RE: STRUCTURAL REVIEW – AUTOMOBILE INTO BLDG.
1160 — 1184 NE DOUGLAS STREET
LEE'S SUMMIT, MISSOURI

JOB #2016-1282

Refer to my report dated July 13, 2016 for the background on this project. After the roof structure was lifted and stabilized, and after some sheathing was removed to allow inspection of the interior connections, I made a second site visit on August 3, 2016 to evaluate the structure and make additional structural repair recommendations. This letter is a summary of my recommendations.

Photo 3 – ceiling joists at track at building wall. Note insufficient bearing. Note screws were not installed in both flanges.

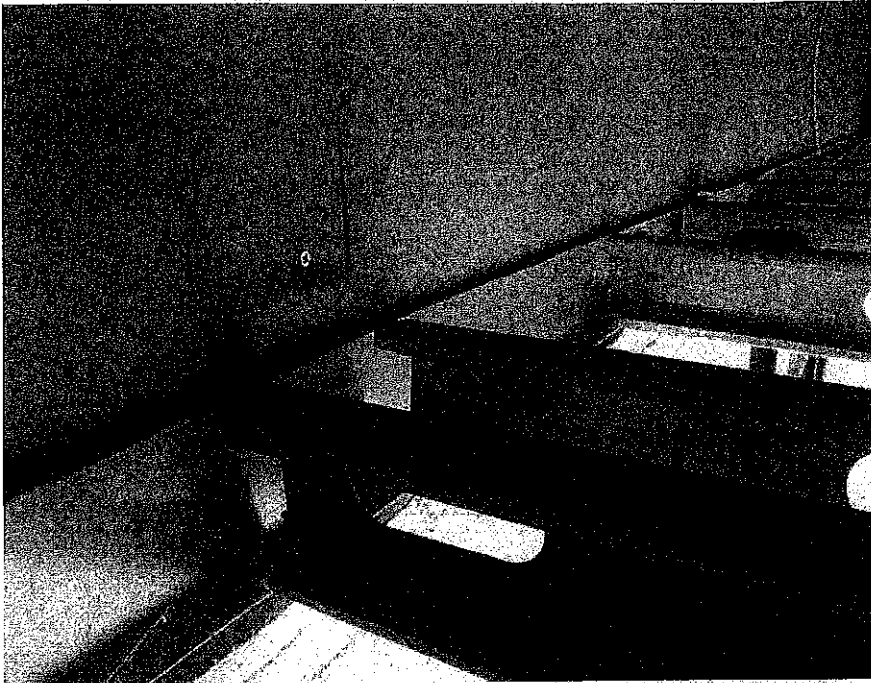
Some ceiling joists are not seated fully into the track at the building wall. See photo. This may be the result of the collapse, and this condition may be corrected after final adjustments are made on the position of the roof, as described below. If this is not corrected after final adjustments, the ceiling joists should be attached to the track with 54 mil steel clip angles with two #10 screws in each leg.

The ceiling joists are 3½" CFS C-shapes at 16" attached to CFS track at both the building wall and the steel HSS beam. All joists and track can be re-used. I recommend attaching each joist to the track with two #8 screws – one in each flange.

Photo 4 – fascia, rafter, and ceiling members

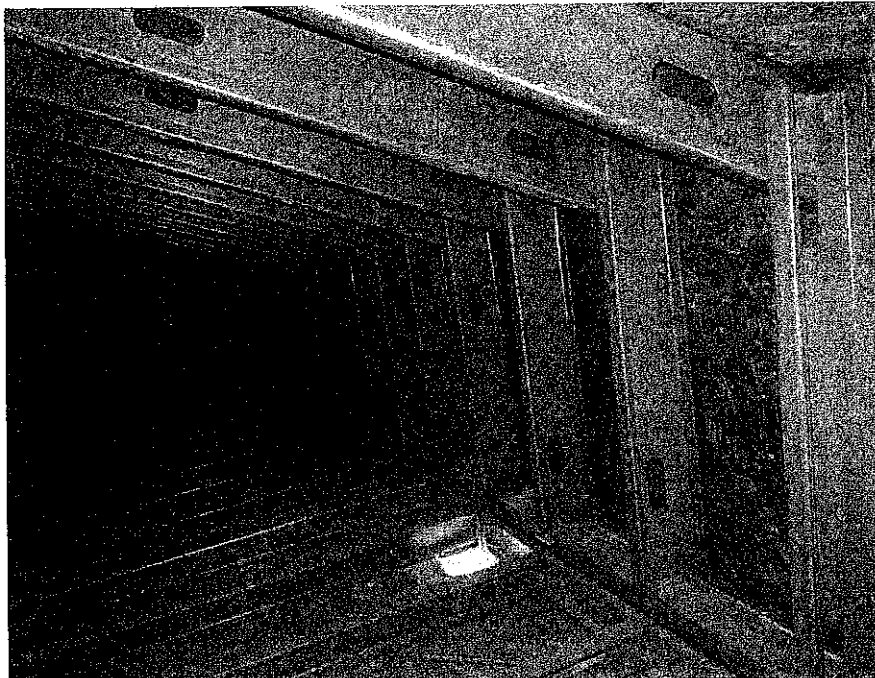
The fascia is framed with 6" CFS C-shapes @ 16" and was originally plumb. At the center of the affected area, where the masonry column was destroyed, the distortion in the fascia is greatest and the top of the fascia leans outward approximately 1½". This distortion should be corrected as described below, and after the fascia is in proper position all fascia-to-rafter connections should be secured with two #10 screws. These screws are in addition to the existing screws.

MASONRY COLUMN - ELEVATION

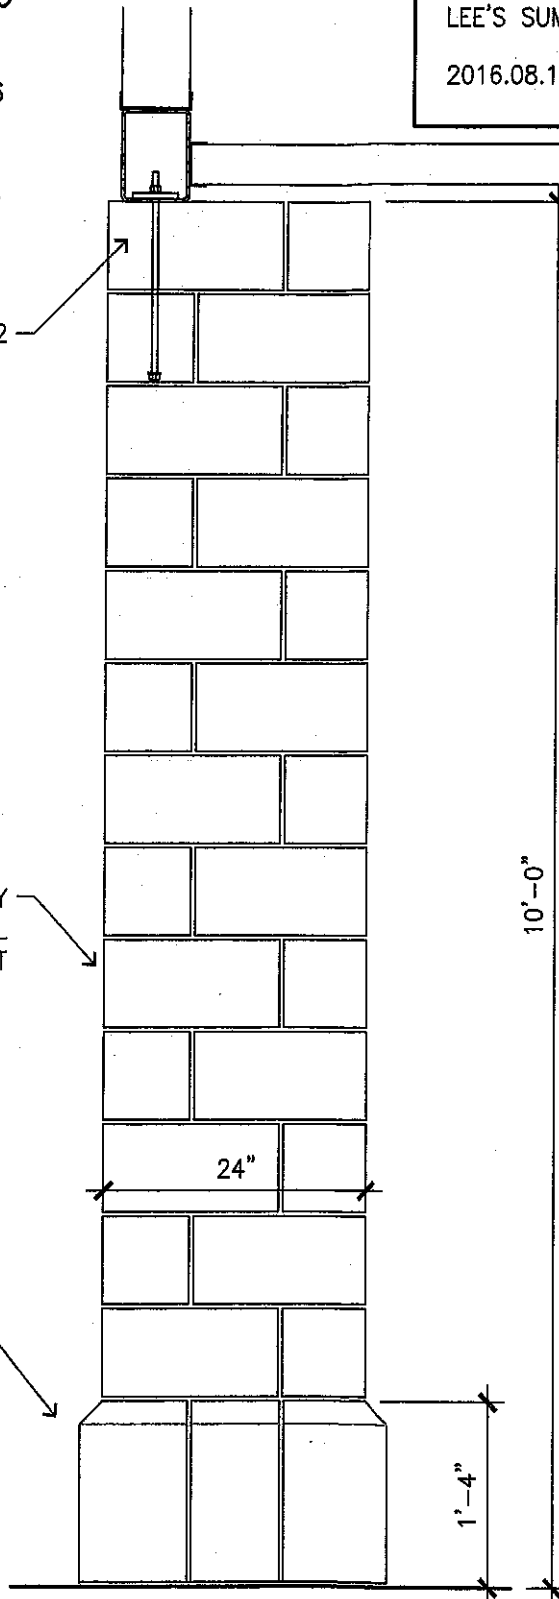
I recommend the load-bearing, masonry column be re-constructed to match the existing columns. Refer to the attached detail. The original construction did not include anchor rods between the masonry column and the footing, and my calculations show that no anchor rods are necessary because of the great weight of the masonry column and the minor uplift loads here.

24"X32" CONCRETE MASONRY
COL. W/ SOLID GROUT IN ALL
4 CORNERS, FULL HEIGHT

2 BEAM CONNECTION DETAIL

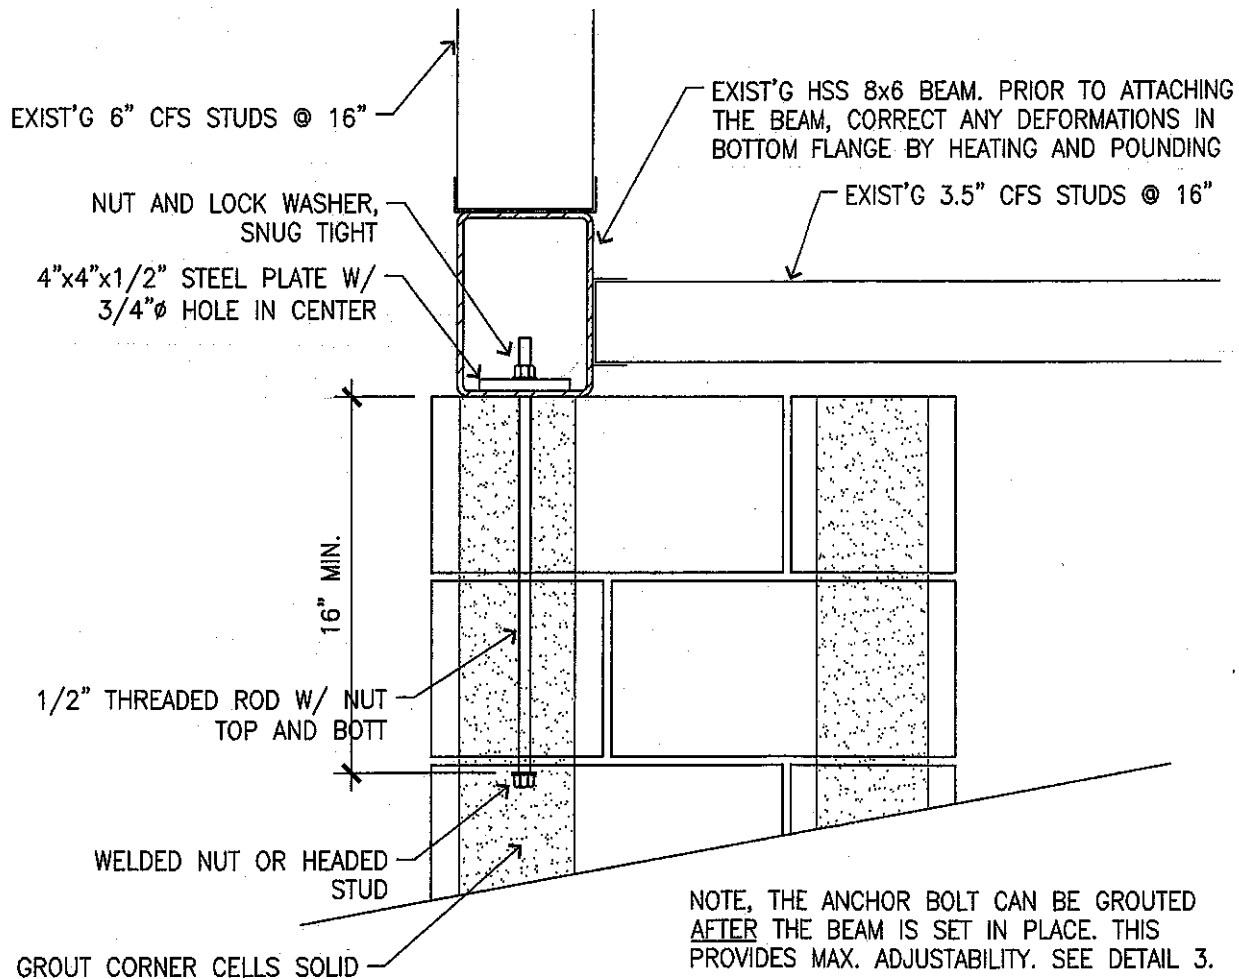
The south beam was damaged by the collision when the anchor bolt was pulled through the bottom flange. I recommend the distorted flange be heated and pounded in so it will sit flush on the masonry. See the attached detail for a connection that does not require welding.
